Rev.	Date	By	Description
			Drawing changed from 318_P_107
D	20.03.15	GL	Tender: Rainwater outlets revised. Levels added
C1	08.07.15	GL	CONSTRUCTION: Amendments as Addendum Bill - Zinc roof to skylights and zinc capping omitted. Replaced by Saranfil roofing membrane, flashings and roof trims.

RICHARD COBDEN PRIMARY SCHOOL, NURSERY
DRAWING : PROPOSED ROOF PLAN
SCALE : 1:50 at A1
DATE : 13.08.14

NOTES

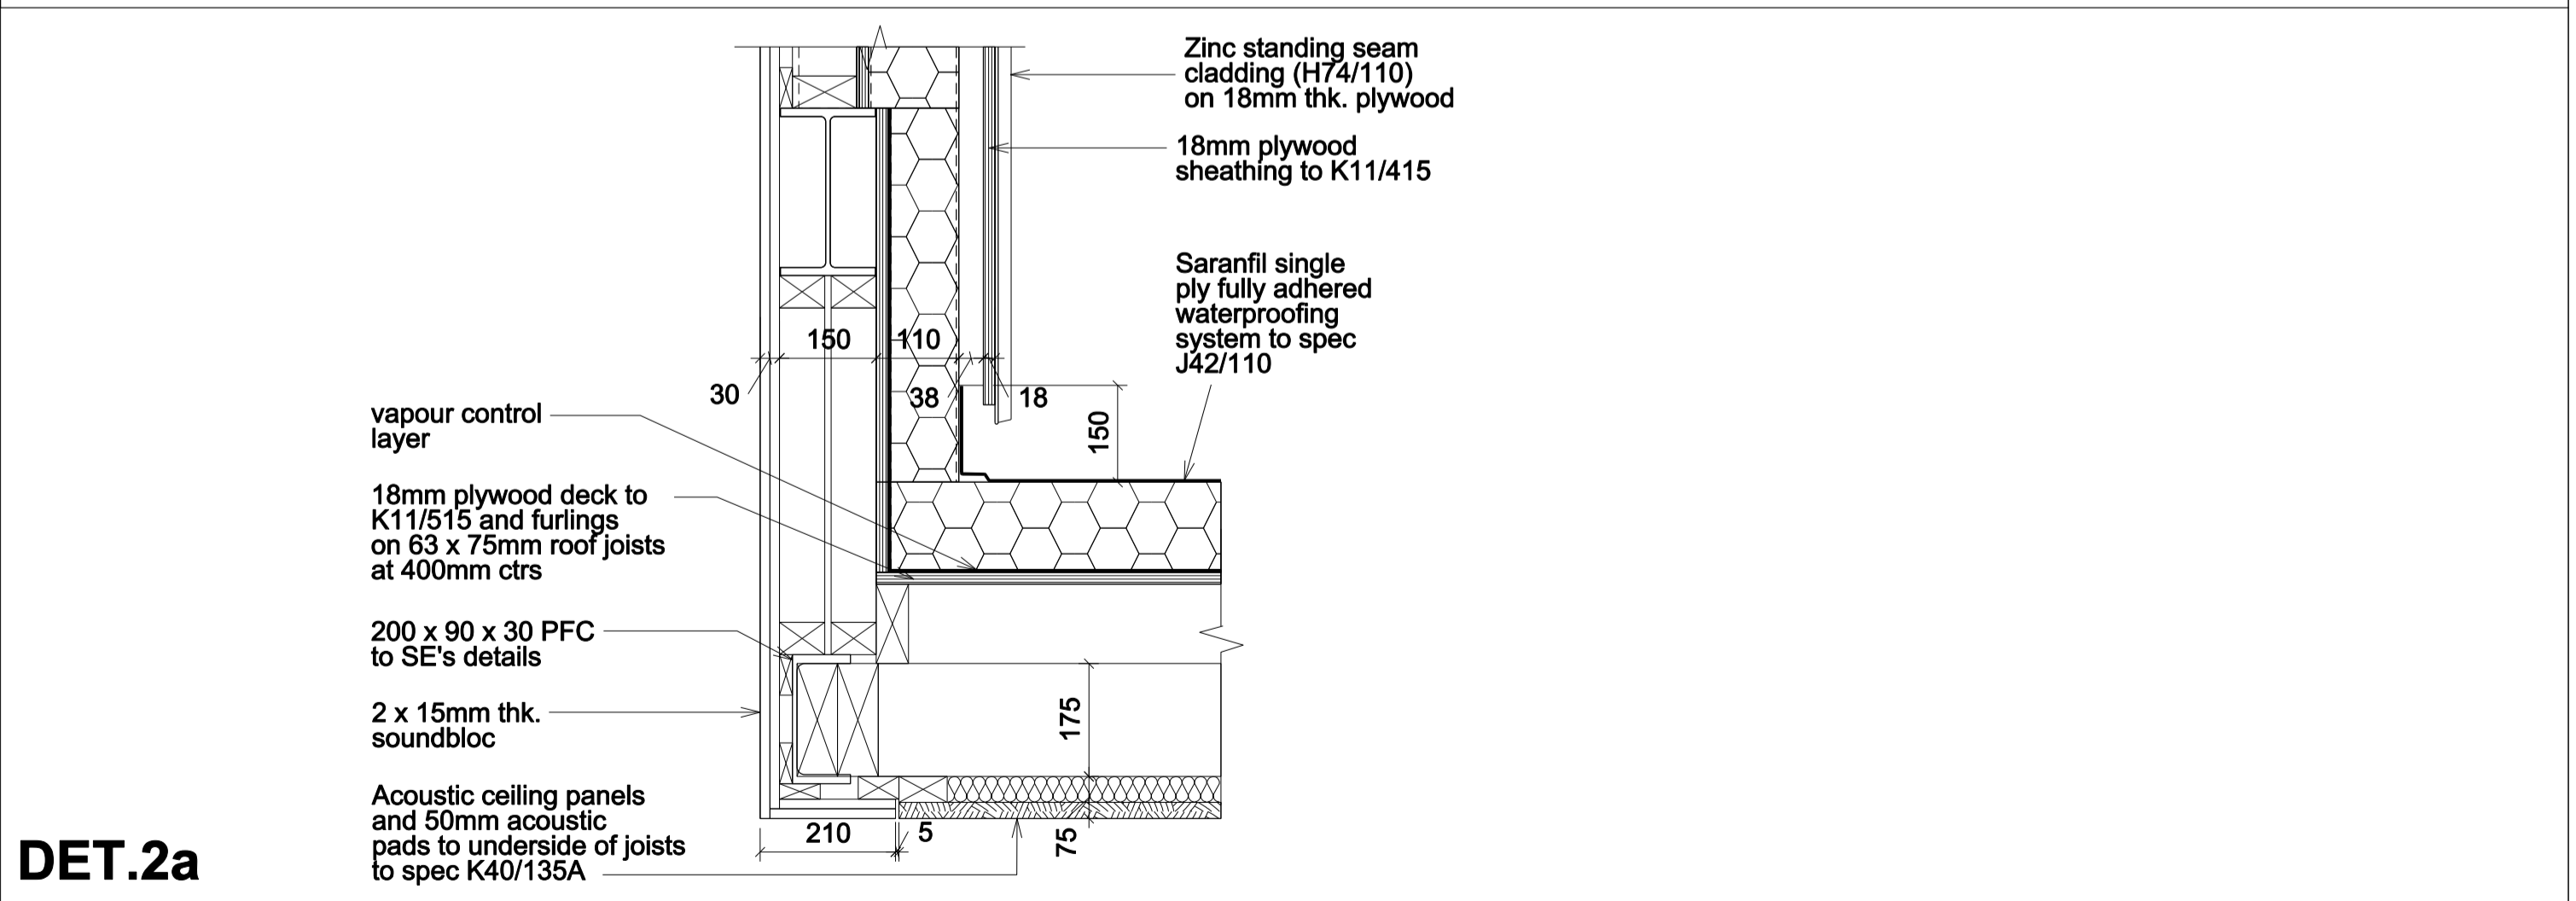
Rev.	Date	By	Description
B	30.03.15	GL	TENDER: NOTES UPDATED
C1	08.07.15	GL	CONSTRUCTION: Amendments as Addendum Bill - ballast margin at green roof omitted, zinc roofing & capping replaced by sarnafil roofing, flashings and roof trims

RICHARD COBDEN PRIMARY SCHOOL, NURSERY
 DRAWING : PROPOSED ELEVATIONS 3 & 4
 SCALE : 1:50 at A1
 DATE : 22.08.14

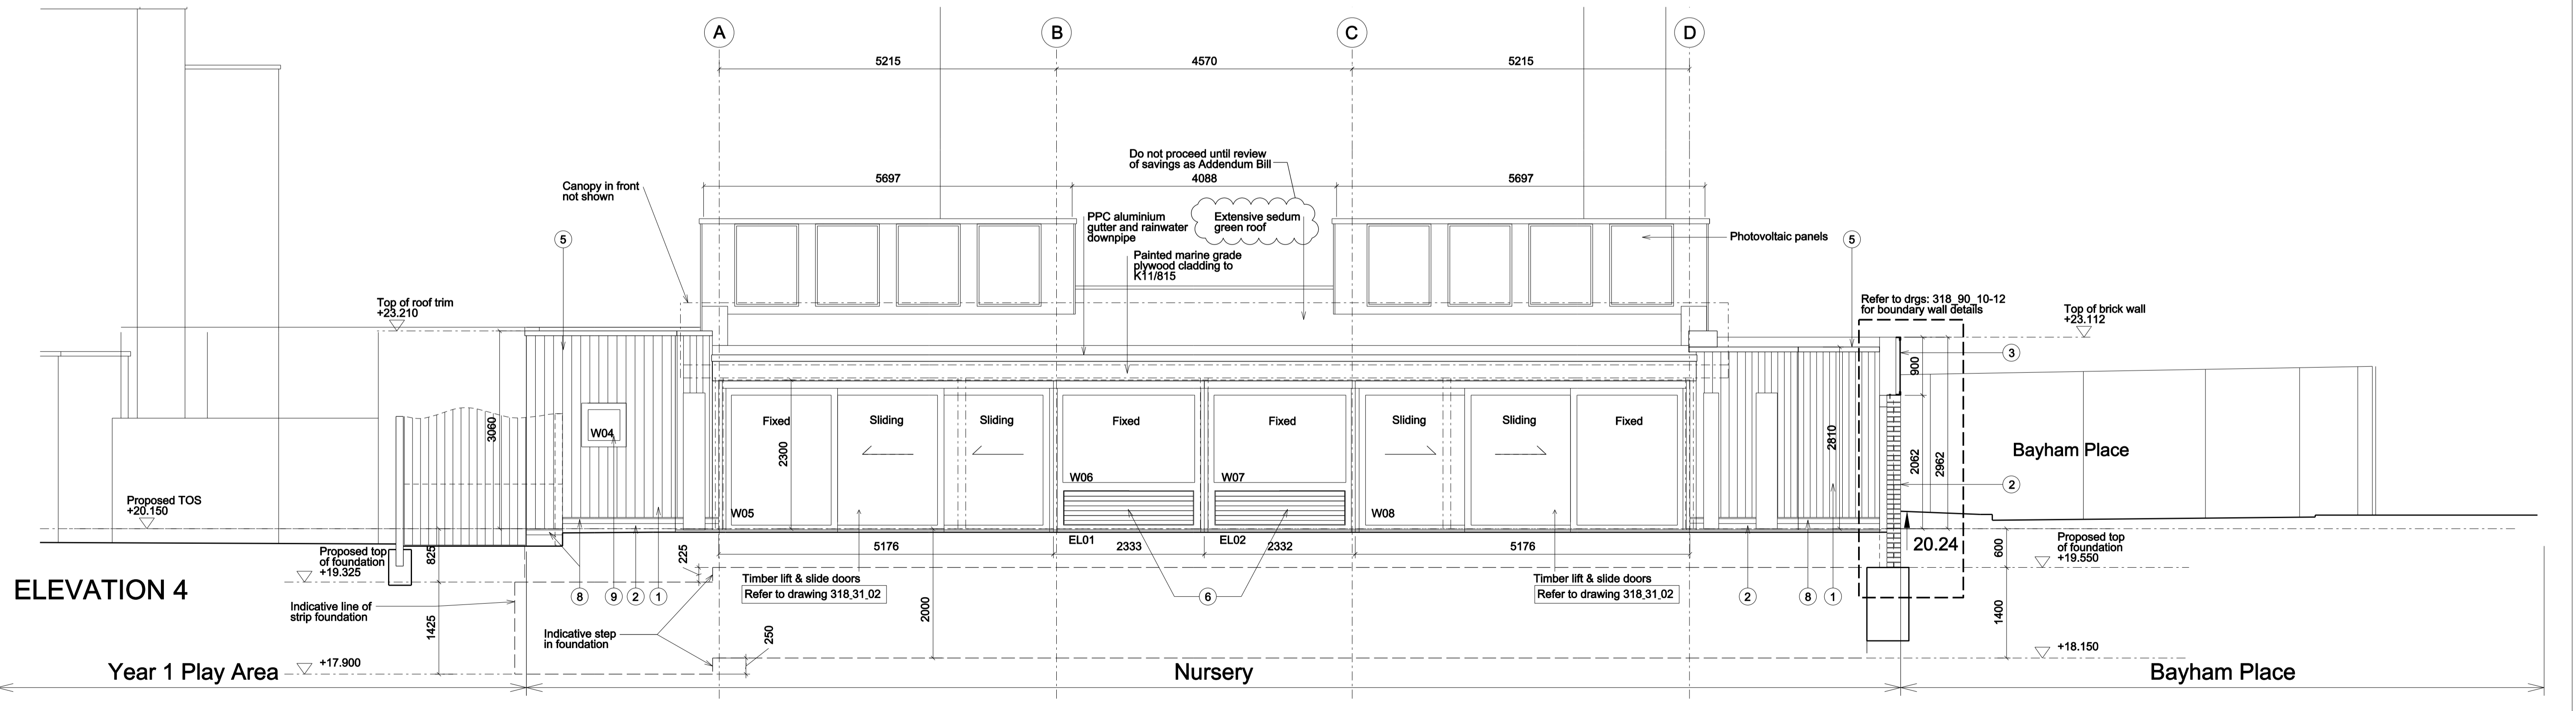
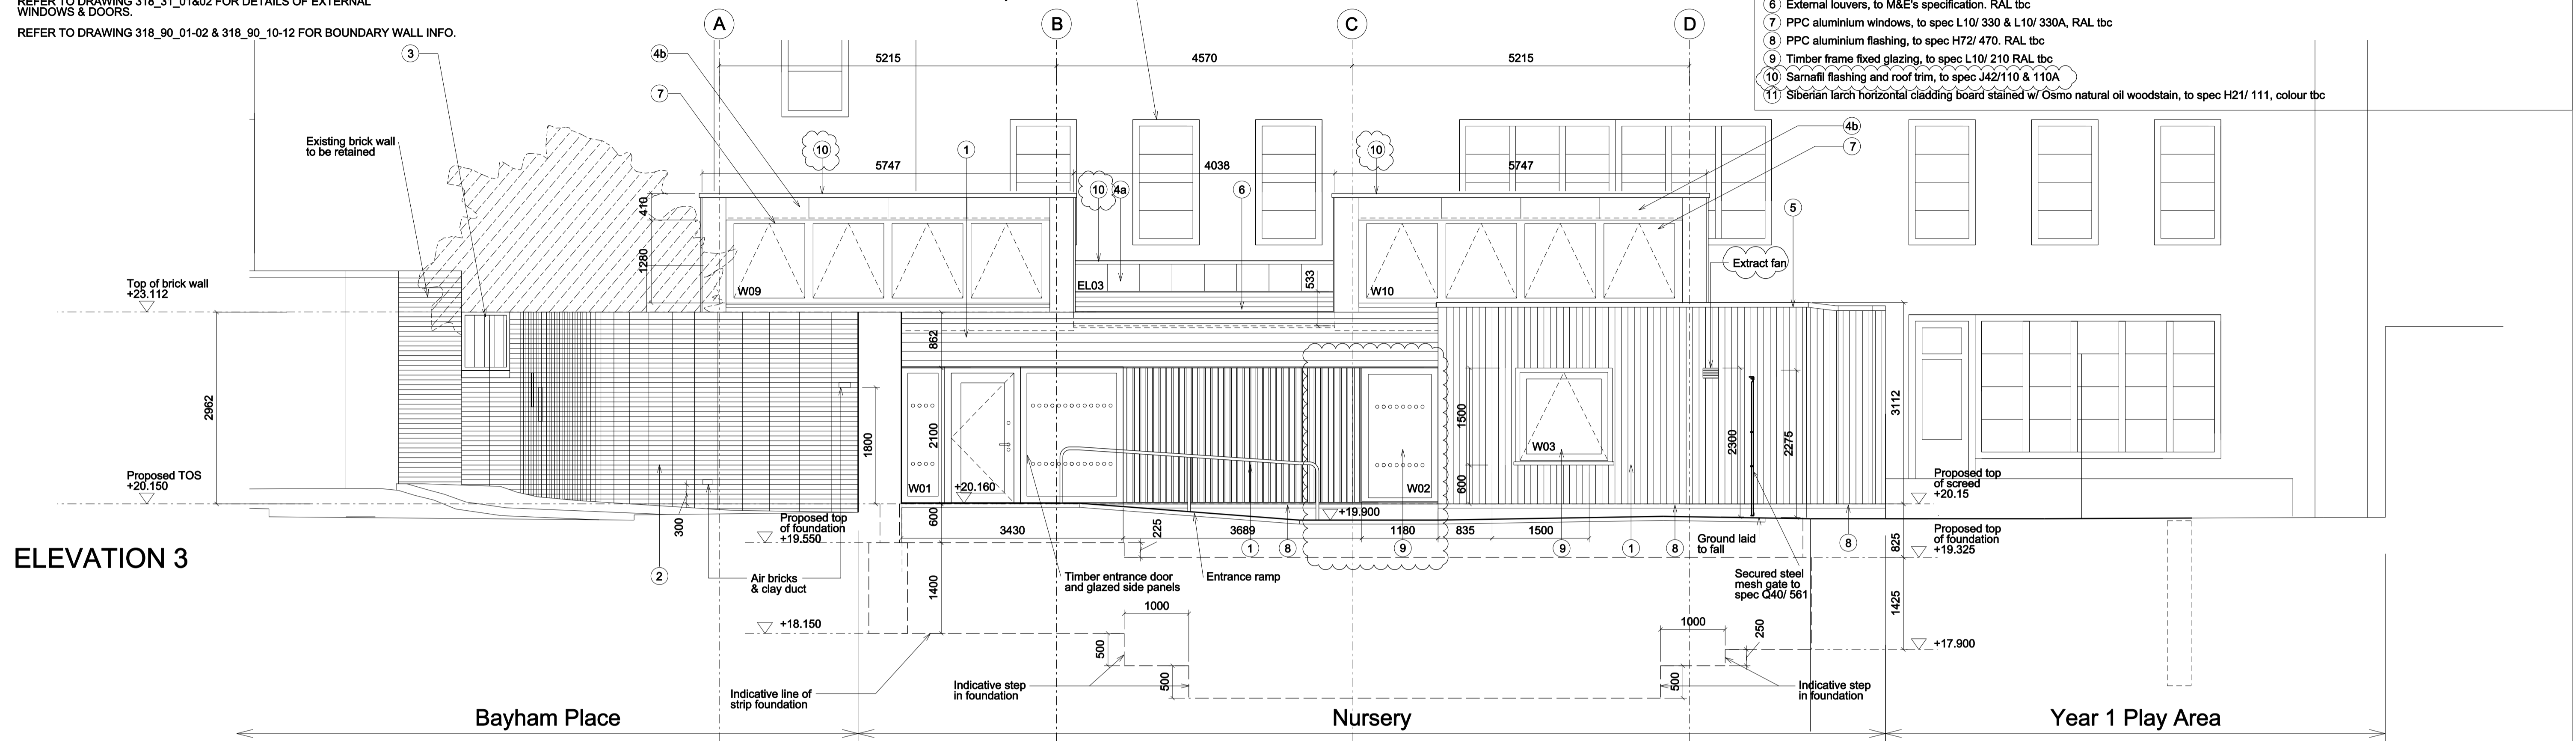
Rev.	Date	By	Description
			Drawing changed to 318_P_105
D	30.03.15		TENDER: ENTRANCE LEVELS & REAR ELEVATION CLADDING REVISED
C1	08.07.15	GL	CONSTRUCTION: Amendments as Addendum Bill - front glazing reduced in width, zinc capping omitted and replaced by samafal flashing and trims. Heat recovery in office omitted.
